ADDENDUM No. 4

MBWWTP SOLIDS PROCESS OPTIMIZATION IMPLEMENTATION PHASE 2 THICKENER UPGRADES CONTRACT NUMBER W-16-017-201

CITY OF CHATTANOOGA, TENNESSEE

d. 01D-10

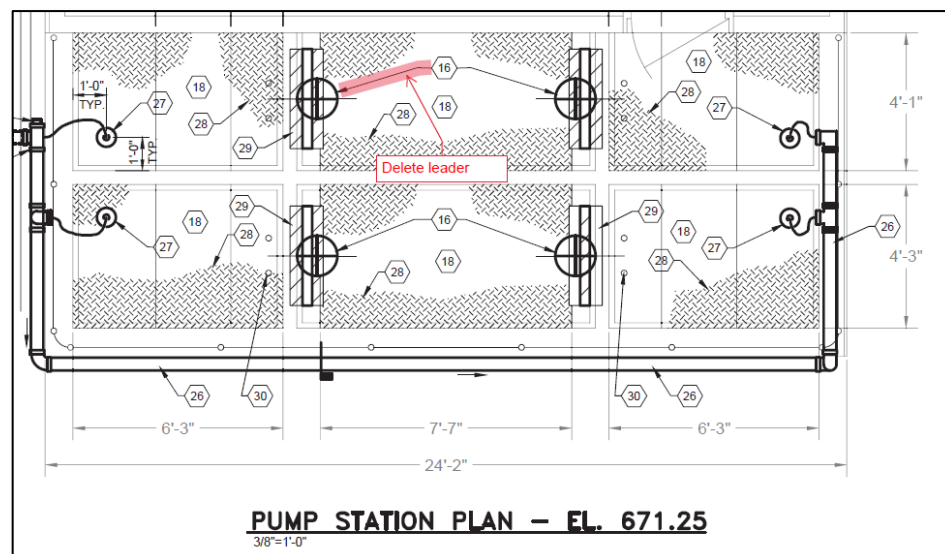
Delete leader from key note 16 to gate at "future tank 6" location. This gate is not being replaced. See sketch below from 01D-09
